FEU INSPECTION REPORT

Re: 1915 Billingsley Terrace, Bronx, NY 10453
a.k.a. 170-184 West Burnside Ave, Bronx, NY 10453

Subject: 6-Story Partially Collapsed Building

Figure #1 – Typical Cavity Wall System (*STRUCTURE Magazine*)

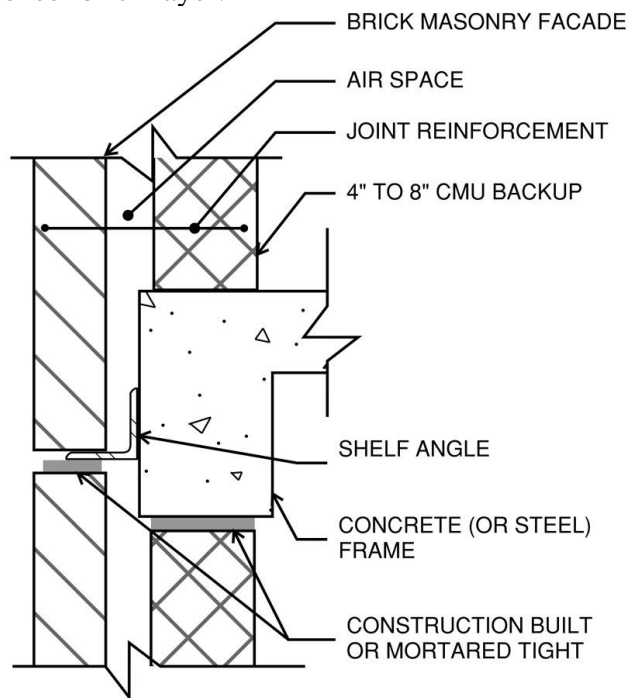
A cavity wall system is a type of exterior wall that has a hollow center (cavity) that is formed with an exterior facing or veneer brick, and an inner “backup” wall with a gap between the two. In a cavity wall system, the exterior wythe (layer) of masonry is not structural and is instead supported by the building structure. Relieving angles support the weight of masonry at regular intervals along the height of the building and transfer the weight to the building structure. Ties provide lateral support to the masonry veneer brick layer.

The exterior walls at 1915 Billingsley Terrace are not a cavity wall system; they are load-bearing solid masonry walls (and piers). Solid masonry walls do not have a cavity, and the individual

Image #7: Original cellar structural plans of 1915 Billingsley Terrace, BX (2023-12-14, FEU)

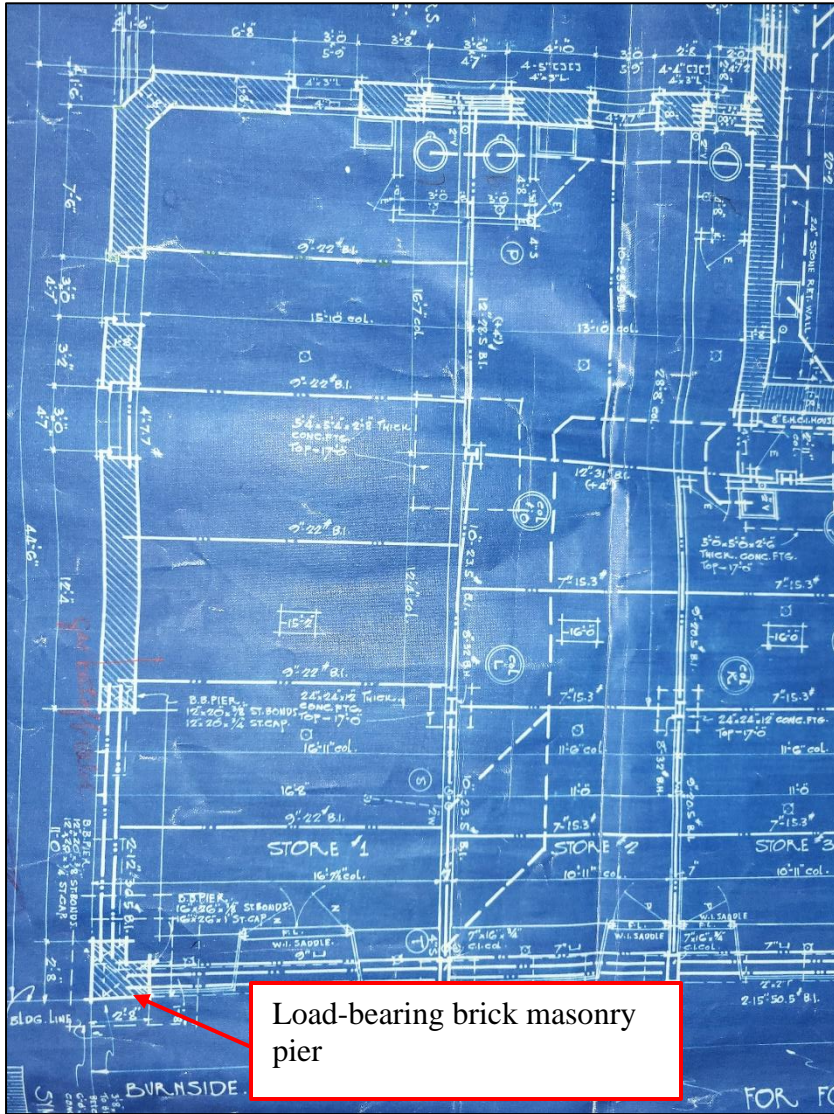
FEU reviewed the original building drawings, Job No. 2632, dated Nov. 10, 1926, prepared by Springsteen & Goldhammer, Registered Architects. Original building drawings were accessed through the Department of Buildings' Records Room. Access to building files at the Department of Buildings archives would have been available upon request to the registered design professional. The cellar level plan shows, at the corner of Phelan Place and West Burnside Ave. (Exposure 1 and 2 corner and collapse location), a B.B. Pier approximately 2'-8" in width and 2'-8" in depth. This pier supports two sets of lintels consisting of a primary I-shaped beam and a secondary C-shape beam, which support the exterior wall and the associated tributary floor areas at the corner of the building. Tributary floor area supported by this brick pier is approximately 13 feet (north-south) by 8 feet (east-west). Elevation drawings for Phelan Place and West Burnside Avenue show this brick pier supported by a 3'-8" wide by 3'-8" deep concrete pier with a 2'-8" thick 6' square footing. See Images #7 through #9 for excerpts from the original building drawings. This is consistent with historic images of the building and what we observed the day of the collapse and subsequent days during partial demolition of the corner to stabilize and remove the debris.

Based on the above, we conclude the corner pier is a load-bearing structural element supporting the weight of the exterior wall at the corner (approximately 21 linear feet), approximately 104 square feet of floor area for each floor (6 floors total), and approximately 104 square feet of roof area.

Image #13: Façade repair drawing elevation showing brick replacement at cellar level load-bearing masonry pier (clouded in red) (2023-12-12, DOB NOW filing)

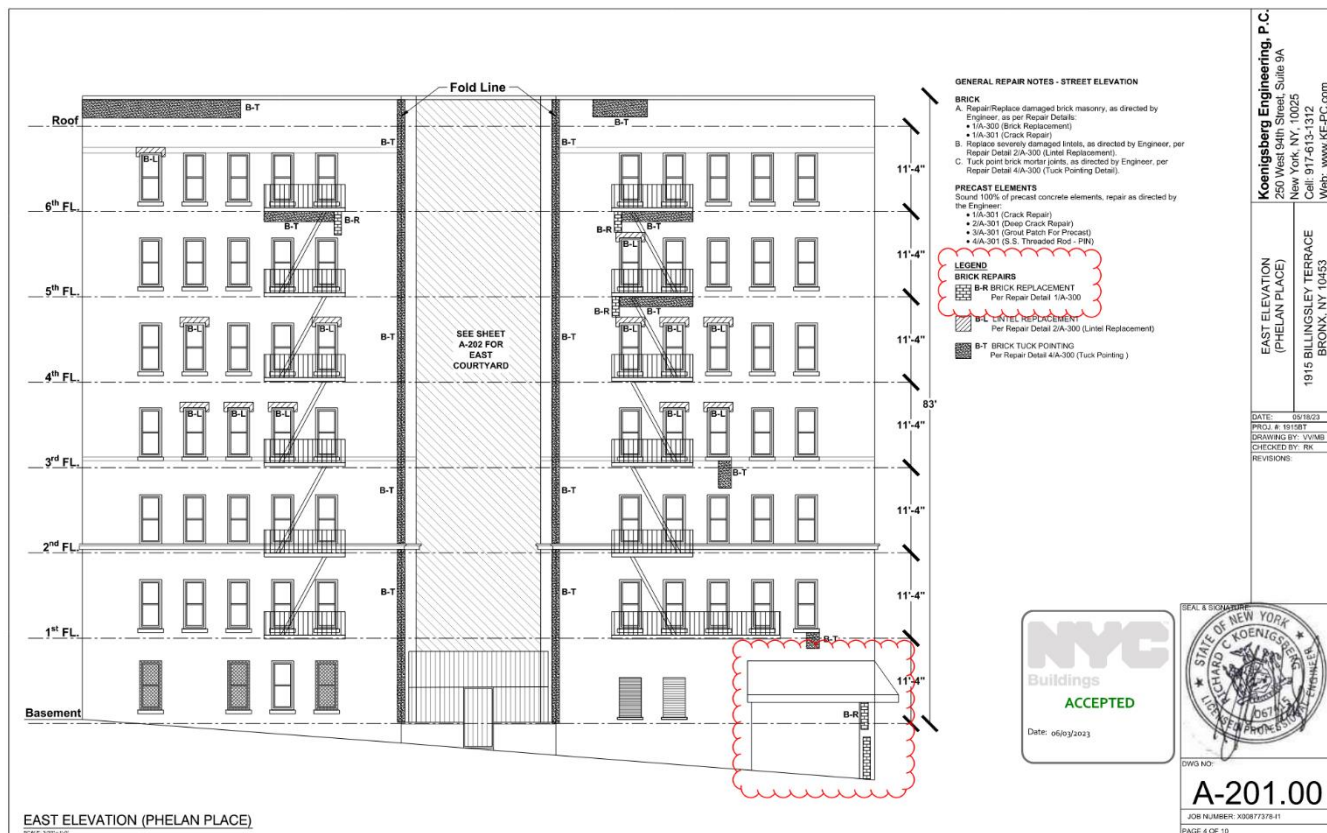
Façade repair drawings by Richard Koenigsberg call for brick repointing, brick replacement, and lintel replacement at various areas throughout the façade. FEU focused review on the brick replacement indicated at the cellar level load-bearing masonry pier on the corner of W Burnside Ave and Phelan Place, Exposure 1 and 2 (the location of the collapse). On the Phelan Place elevation in the façade repair drawings (see Image #13), hatching is indicated on the cellar level load-bearing masonry pier which corresponds to “B-R Brick Replacement” on the legend. This legend refers us to detail 1/A-300 for a typical detail for brick replacement. Upon review of detail 1 on sheet A-300, the typical brick replacement detail shows a cavity wall system with one wythe of face brick anchored to a backup wall with stainless steel ties, leaving a gap between the two materials (See Image #14).

The design applicant did not sufficiently or correctly indicate the exact nature and extent of the work proposed at the cellar level load-bearing masonry pier. Repair drawings do not indicate that this pier is a critical structural member supporting a significant floor area from the 1st floor through the roof, nor do the drawings propose or indicate shoring or other means of performing the specified brick replacement work in a safe manner. If there were doubts as to the nature (construction type, whether load-bearing or not, etc.) of this pier, it was not addressed on the drawings, nor were any probes or investigations indicated as required.

2. Façade repair drawings by Richard Koenigsberg call for removal and replacement of brick at the pier. Furthermore, this pier is identified (incorrectly) as a cavity wall system in his drawing set. Repair drawings do not indicate that this pier is a critical structural member supporting a significant floor area from the 1st floor through the roof, nor do the drawings propose or indicate shoring or other means of performing the specified brick replacement work in a safe manner. If there were doubts as to the nature (construction type, whether load-bearing or not, etc.) of this pier, it was not addressed on the drawings, nor were any probes or investigations indicated as required.
